Economic Commission for Europe**Inland Transport Committee****World Forum for Harmonization of Vehicle Regulations****Working Party on Lighting and Light-Signalling****Ninety-first session**

Device UN Regulations:**UN Regulation No. 148 (Light-Signalling Devices)****Proposal for a Supplement to the 01 series of amendments to UN Regulation No. 148 and to the 06, 07, 08 and 09 series of amendments to UN Regulation No. 48****Submitted by the expert from the International Automotive Lighting and Light-Signalling Expert Group***

The text reproduced below was prepared by the expert from the International Automotive Lighting and Light-Signalling Expert Group (GTB) with the aim to introduce reversing projections. The proposal is based on informal document GRE-90-16. The modifications to the existing text of the UN Regulation are marked in bold for new or strikethrough for deleted characters.

6.27.3. Arrangement

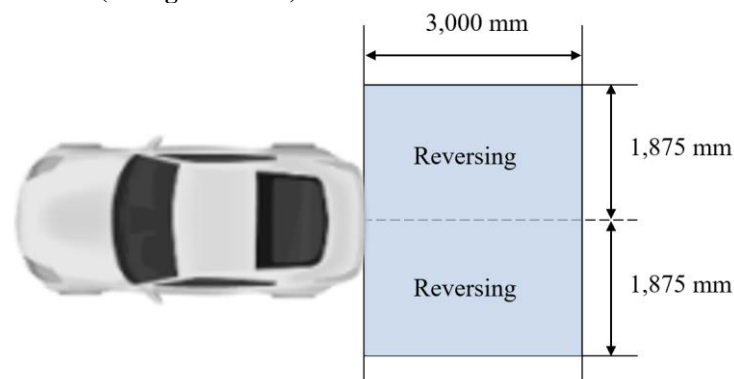
Such that the provisions of paragraphs 6.27.5., 6.27.6. and 6.27.9. are fulfilled.

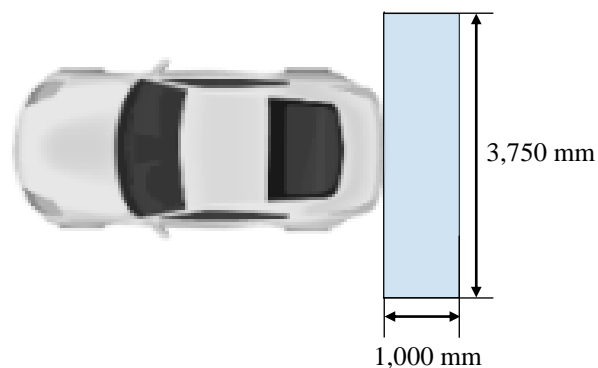
- 6.27.5.1. The lateral distance from the outer edge of the projection with respect to the longitudinal plane of the vehicle shall not be more than 1,875 mm. The longitudinal distance from the farthest edge of the projection shall not be more than 3,000 mm from the backward extreme outer edge of the vehicle (see figure below).**

6.28.3. Arrangement

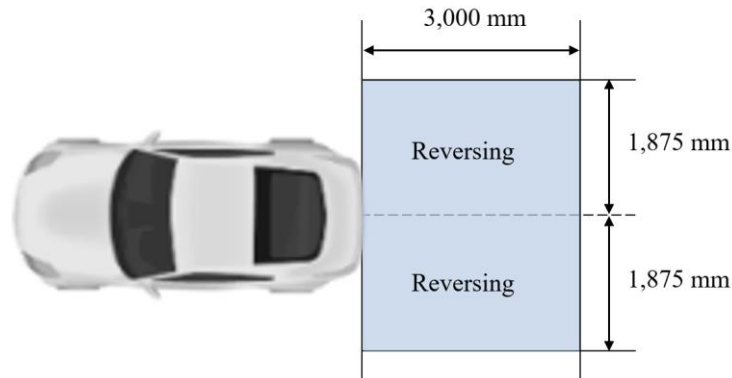
Such that the provisions of paragraphs 6.28.5., 6.28.6. and 6.28.9. are fulfilled.

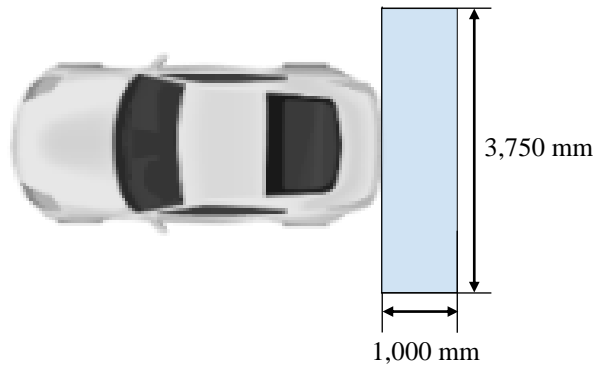
6.28.5.1. The lateral distance from the outer edge of the projection with respect to the longitudinal plane of the vehicle shall not be more than 1,875 mm. The longitudinal distance from the farthest edge of the projection shall not be more than 3,000 mm from the backward extreme outer edge of the vehicle (see figure below).
